Proposed Zoning Changes to regulate Low-Rise Residential Infill in the General Urban Area

ADDENDUM

Sketch 1

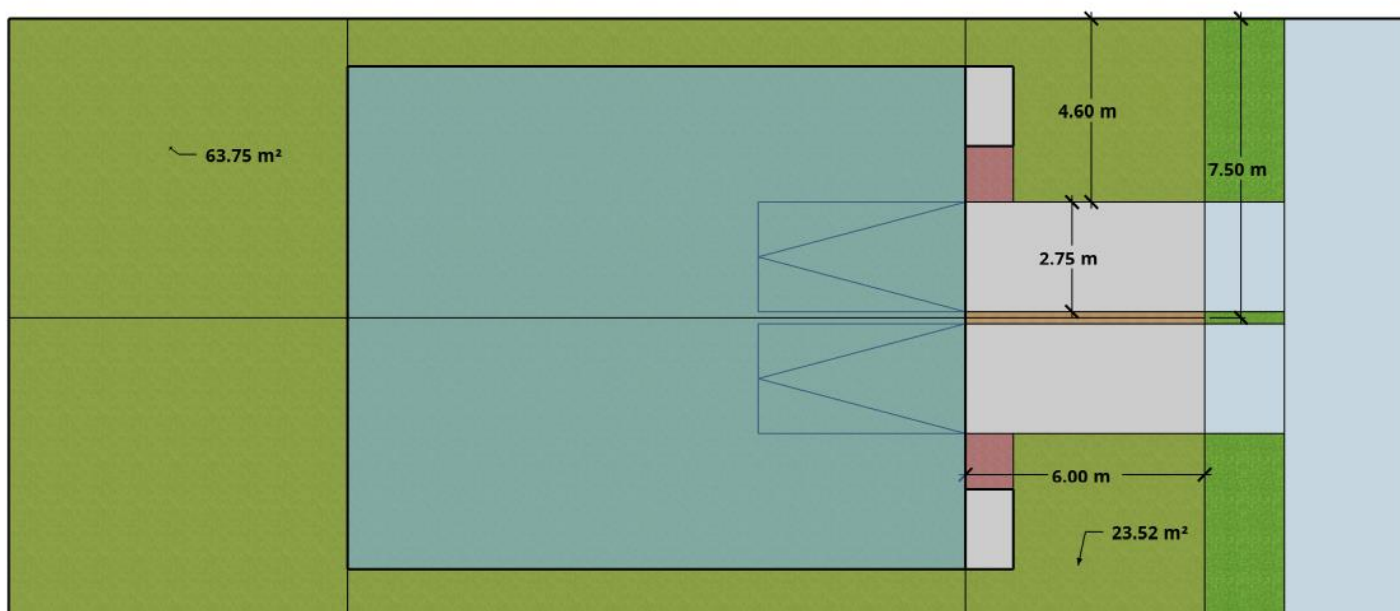
Sketch 1 shows the common side-by-side integral garages accessed by individual driveways, with the proposed small landscaped separation between the driveways to provide a visual cue that these are single driveways. This design results in sufficient soft landscaped area in the front yards, as well as significant amount in the rear yard. However, the garages and driveways are central on the original lot and remain prominent rather than the areas that are softly landscaped. Further, the infill or redevelopment has removed the on-street parking in front of this development, which would be a problem on streets where residents rely on some on-street parking either for themselves or for guests.

Sketch 2

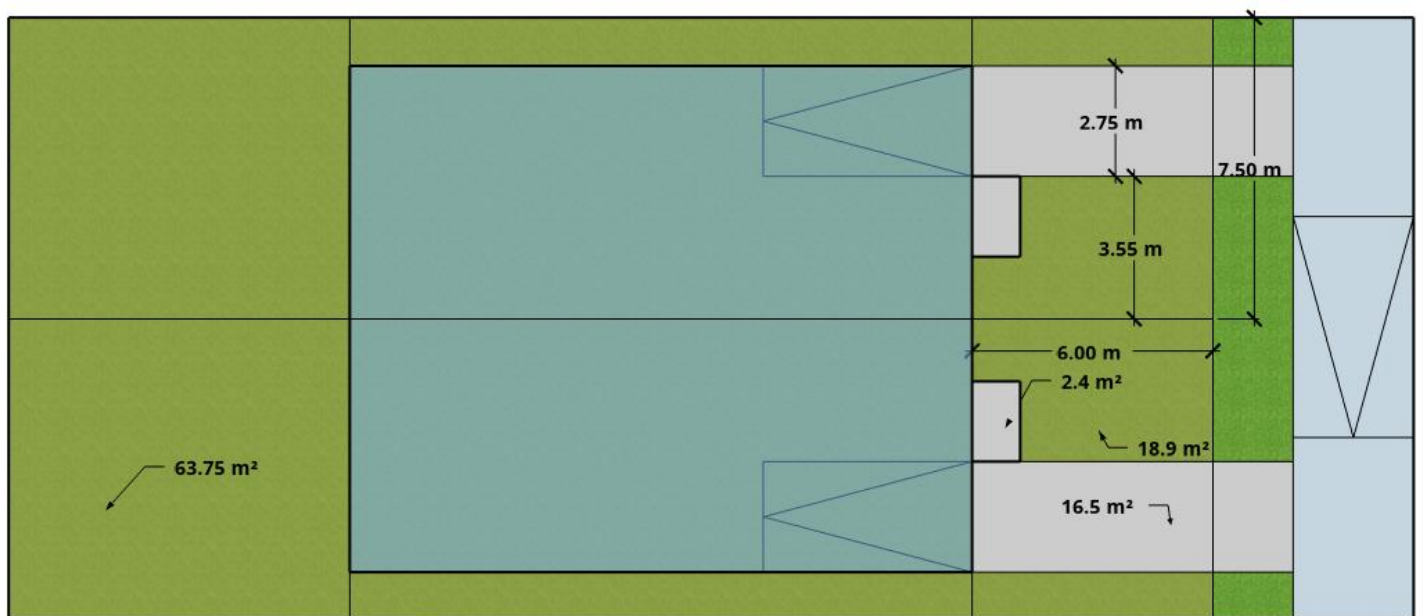
Sketch 2 shows a semi-detached with two attached garages, each accessed by single driveways leading to the parking spaces located in the garages. On a lot that is 7.5 m wide, with a 6 m front yard setback, the amount of soft landscaped area is 18.9 m². This is an appropriate design on those streets where garages and carports are the dominant character, and where the spacing of the driveways and separation of the garages is common. This is an ideal design where each unit has on-site parking, a pristine rear yard not used for parking, one on-street parking space, and a significant amount of soil volume to enable a City-owned tree in the right-of-way.

Sketch 3

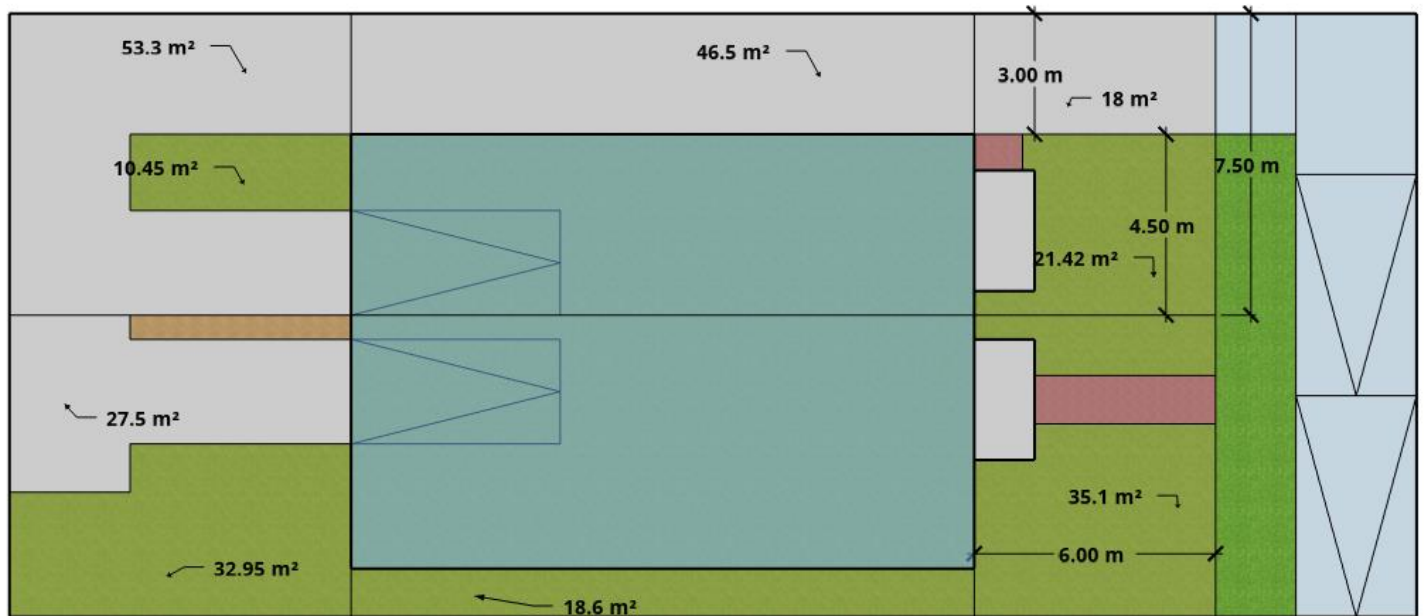
Sketch 3 shows a semi-detached with a shared driveway 3 m-wide running the length of one of the dwelling unit's interior side lot lines, to two rear-facing integral garages. Many streets in the mature neighbourhoods have these side yard driveways leading to rear yard parking, though usually in detached garages. Even though these may fit in with the character along a street, there is far less rear yard area for soft landscaping and amenity space. The driveway is long. Some residents will not clear the entire length of it during the winter, and it would be far more difficult and costly to be removed in the future. It also requires an easement permitting the second dwelling unit's owner to access the shared driveway. However, there is more soft landscaped area in the front yard, and with only one driveway, there is room for two on-street parking spaces. Adding a second walkway back from the right-of-way would not have any significant result, nor lower the amount of soil volume that would be available to support a tree. A similar design would occur if there were a shared driveway leading to rear yard surface parking or rear detached garages.

Sketch 4

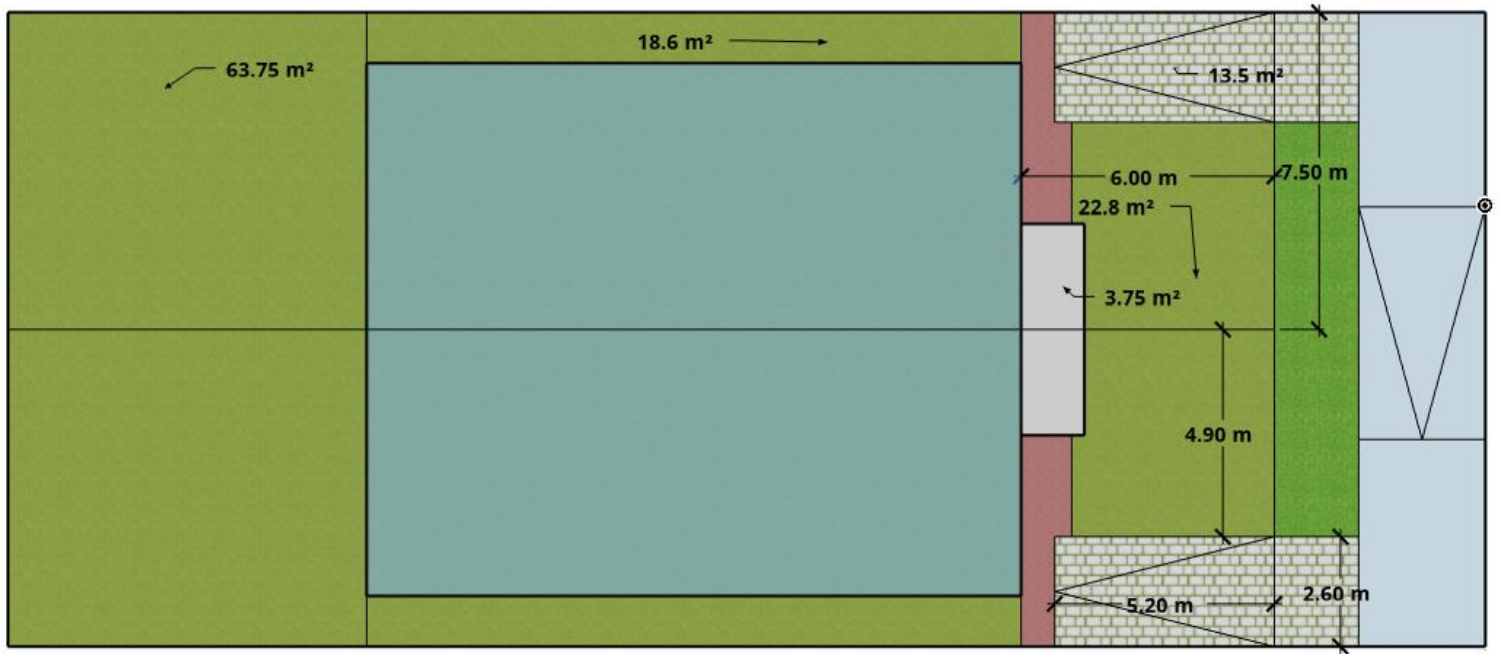
Sketch 4 shows one front yard parking space per dwelling unit located at the outer edges of the original lot, along the non-common interior side lot lines. A path between the top of the space and the dwelling unit provides pedestrian access. Walkways are not necessary and are proposed to be prohibited back from the right-of-way to the entry.

Sketch 5

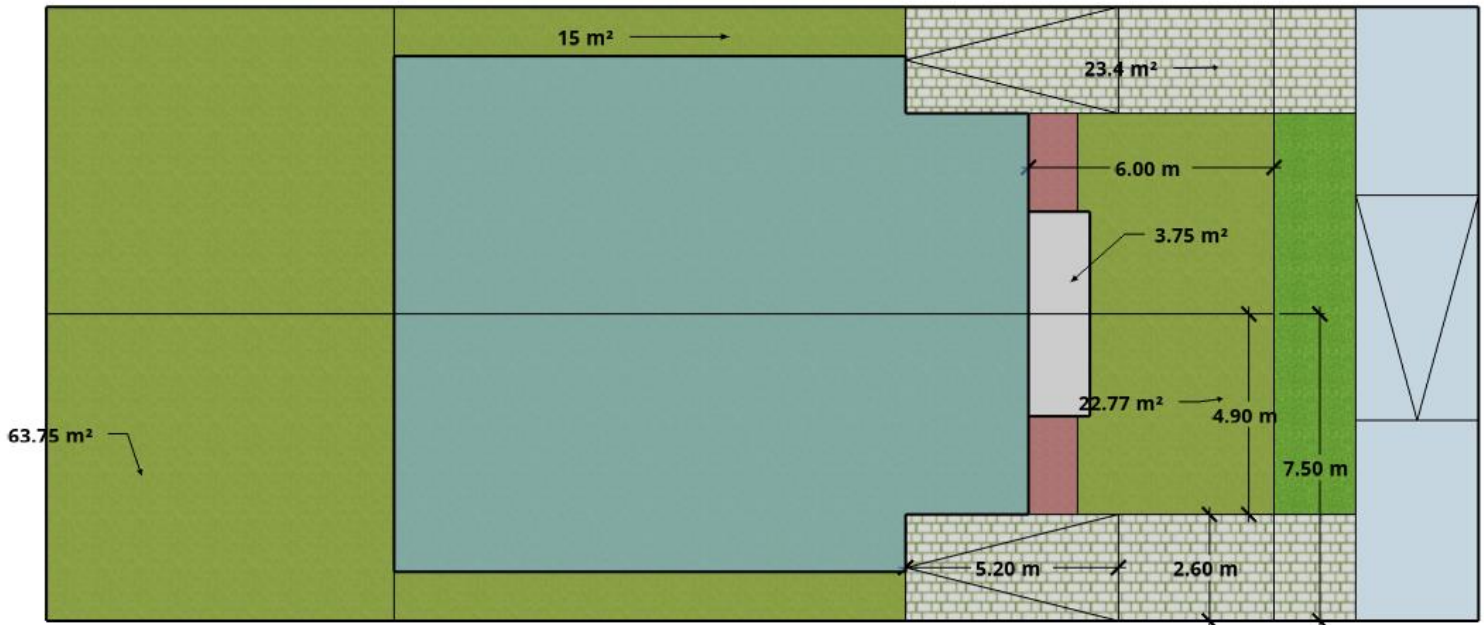
Sketch 5 shows one front yard parking space at the outer edges of the original lot, along the non-common interior side lot lines. Walkways are not necessary. This design shows notches cut out of the first storey of the dwelling units to allow for the tucking in of the front yard spaces. This results in a longer parking pad, that could result in a second car being parked in tandem, though it would result in illegally parking within the right-of-way. This notched design would occur also on a lot with a front yard setback, such as 3 m or 4.5 m, that is less than the minimum length of 5.2 m required for a parking space. The notched area provides partial shelter for the car.

Sketch 6

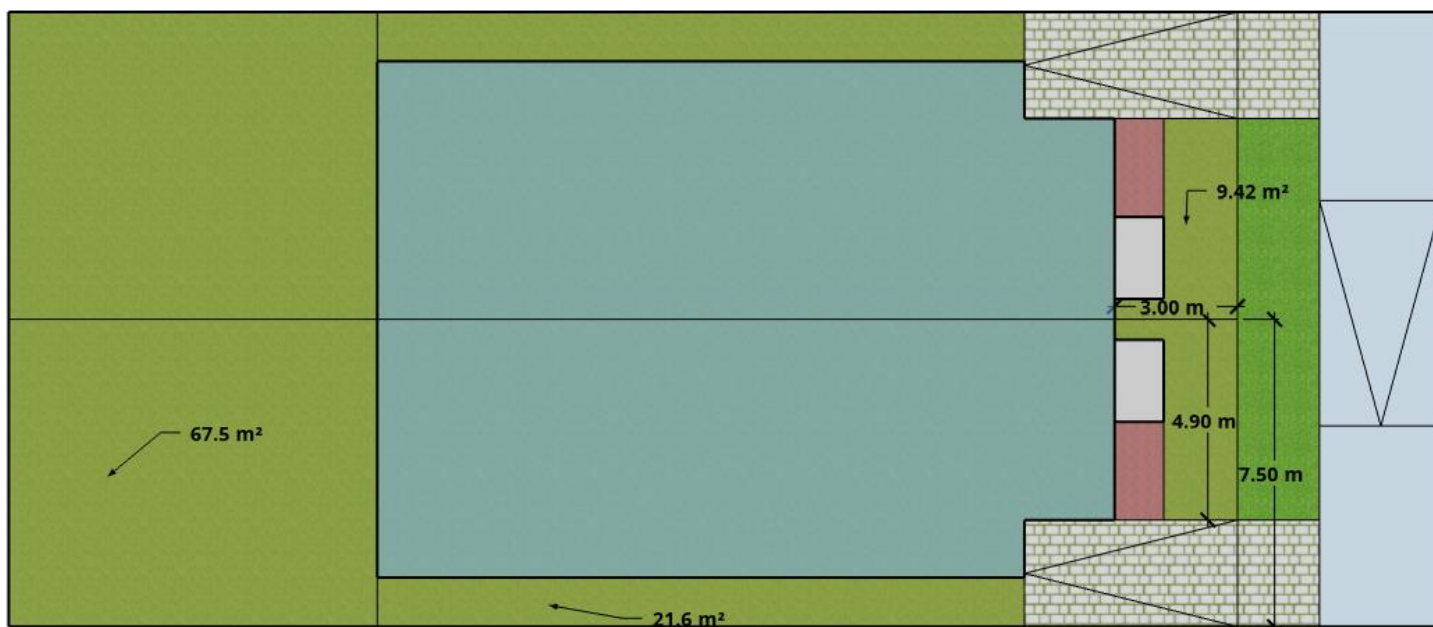
Sketch 6 shows two front yard parking pads on a lot with a front yard setback of 3 m. In this case, there would have to be a notch in the footprint of the dwelling to enable the space to meet the minimum width and length required (2.6 metres and 5.2 metres, respectively). The design allows for partial protection of the car from inclement weather. The design also allows a prominent place for soft landscaped area in the middle of the original lot, in front of the main entranceways while leaving the rear yard free from parking. One on-street parking space is enabled.
